NOTICE OF ADDENDUM ADDENDUM NO. 1

CONTRACT NO. 8850, PROJECT NO. 11971 WARNER BEACH PARK SHELTER

Pre-Bid Meeting/Site Visit
WARNER BEACH PARK SHELTER
CITY OF MADISON - CONTRACT #8850

- EXHIBIT K EXISTING BUILDING DRAWINGS response to Bidder Question in Item #7
- Pre-Bid Walk Through Sign-in sheet and Minutes from June 24, 2020 in Item #7

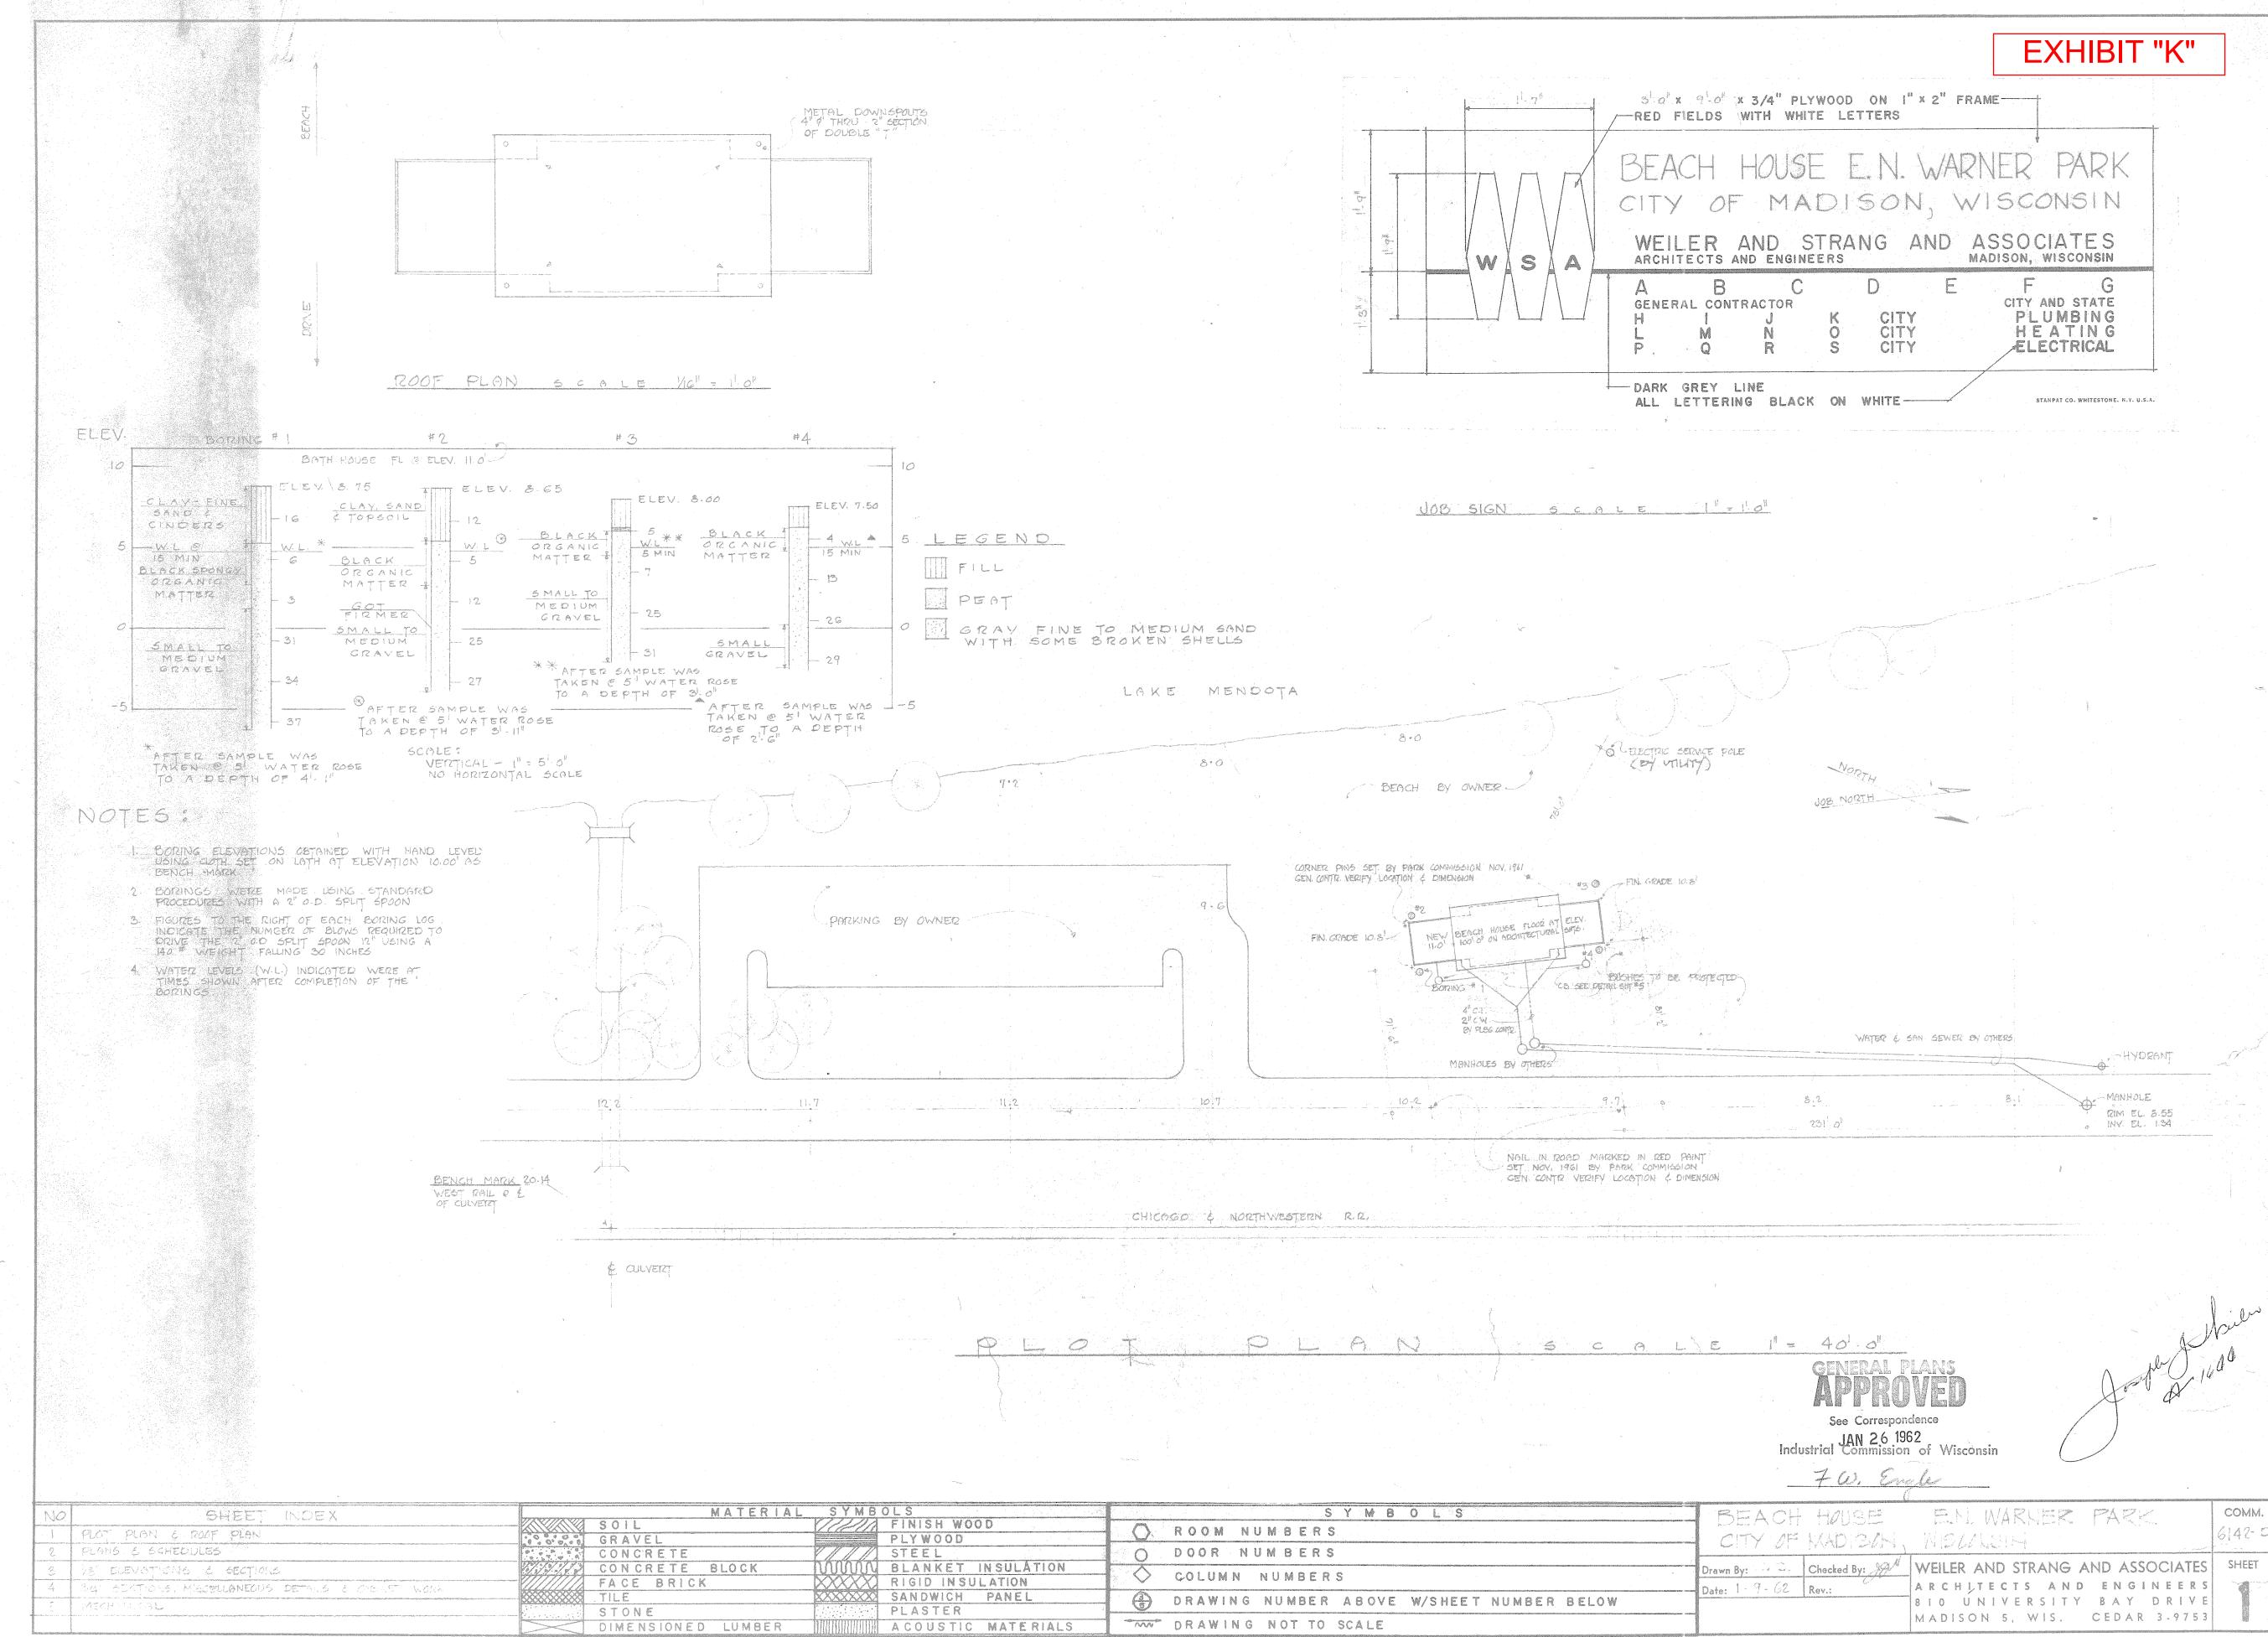
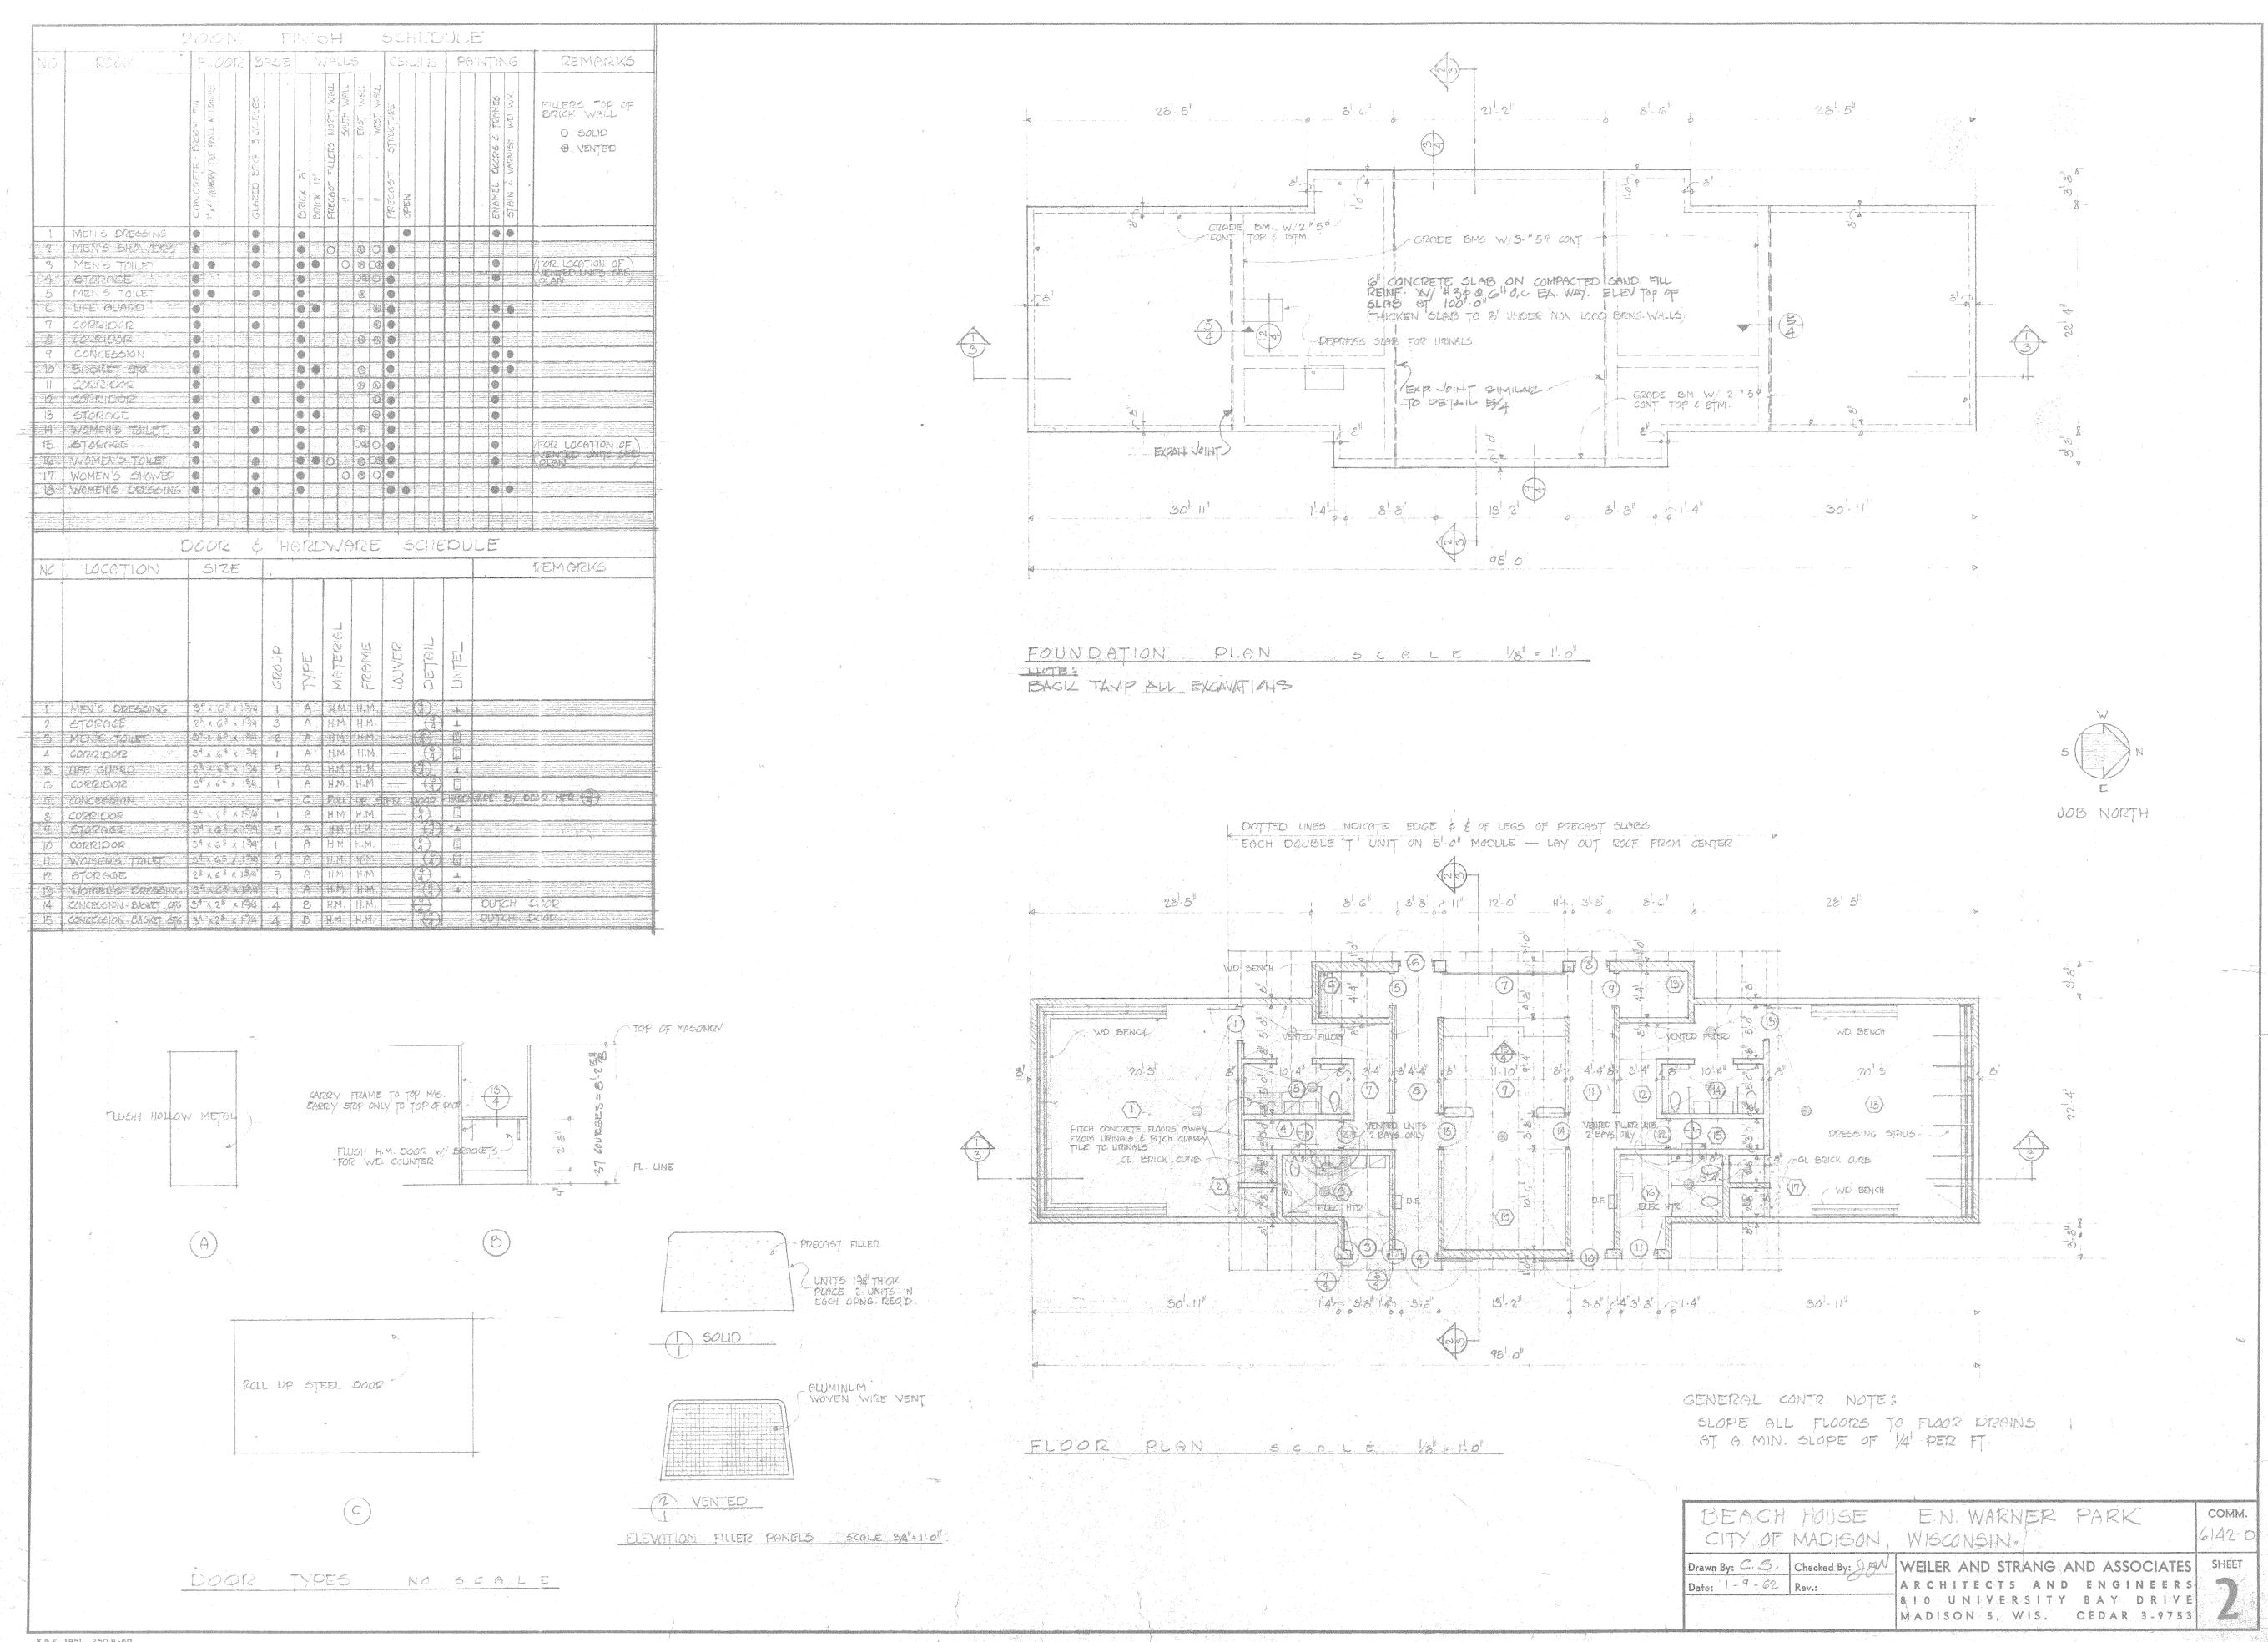
Q1: What is the foundation of the existing building?

A1: Existing plans show grade beams at the building perimeter and thickened slab under non load bearing masonry walls. See Addendum 1, Exhibit K
